# CAPRICORN MUNICIPAL DEVELOPMENT GUIDELINES

## 2023 MEETING 5 MINUTES

**Date and Time:** 23<sup>rd</sup> June at 11:00 am

**W-090****W090A**

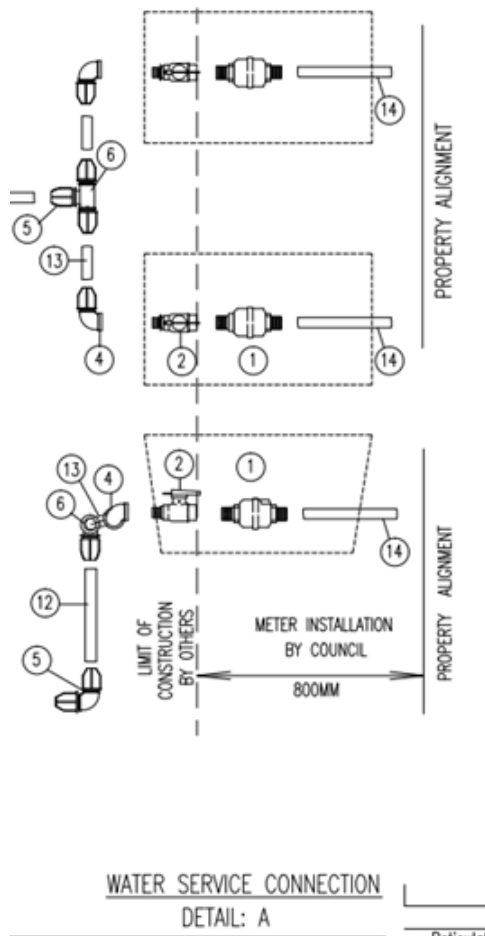
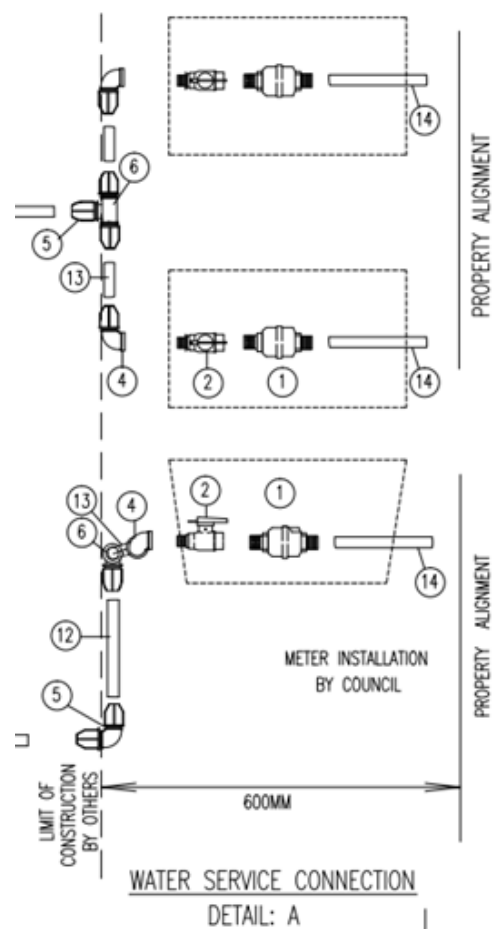
As part of an update to W-090 it was noted that the differences between W-090 and W-090A are minor and there may be an opportunity to combine them.

The key difference between the drawings W-090 and W-090A is the water service connection detail:

The other difference between the drawings is just the short single size on the W-090A is 25mm not 32mm, this could be covered in the applicability table if required.

The main benefit from not installing the valve is reduction in the risk of water theft.

Brief discussion on whether other LGA have experienced water theft. RRC noted that they (FRW) have had no issues. General agreement to maintain current practices. MRC noted no particular preference but would default to current arrangement unless general consensus to change.

Raised that GRC detail does not actually provide a connection to each individual property which may technically not comply with planning scheme.

<p>MCE wait for response from GRC and depending on outcome investigate whether there is space to have both details on one drawing with a table of difference.</p> <p><u>M2023.05 Resolution</u></p> <p>GRC confirmed that they wish to maintain the requirements shown on W090A as these match current practices. MCE to look into merging the two drawings W090 and W090A to create a single drawing with the differences noted in a table of difference/ alternative details.</p> <p><u>Action By</u> MCE.</p>
M23.01.06	<p><b>C224 – Open Drains - No resolution this meeting</b></p> <p>Brendan noted that he was looking for table drain information and this construction specification contains the relevant information. A title change was suggested or potentially adding this information to the drainage design specification D5.</p> <p>For discussion.</p> <p style="text-align: center;"> <b>CAPRICORN MUNICIPAL DEVELOPMENT GUIDELINES</b> </p> <p style="text-align: center;"> <b>OPEN DRAINS INCLUDING KERB &amp; GUTTER (CHANNEL)</b> </p> <p style="text-align: center;"> <b>C224</b> </p> <p style="text-align: center;"> <b>CONSTRUCTION SPECIFICATION</b> </p> <p><u>M2023.04 Discussion</u></p> <p>Discussions around what should be included in C224 vs D5 as some of the information currently in C224 is more focused on design requirements. Some rewording to the text or titles may be possible to make the requirements for Table Drains more obvious.</p> <p><u>M2023.04 Resolution</u></p> <p>Brendan/ GRC to review document and consider which elements can be moved to D5 and provide feedback/ and updated C224 document.</p> <p><u>Action By</u> GRC</p>
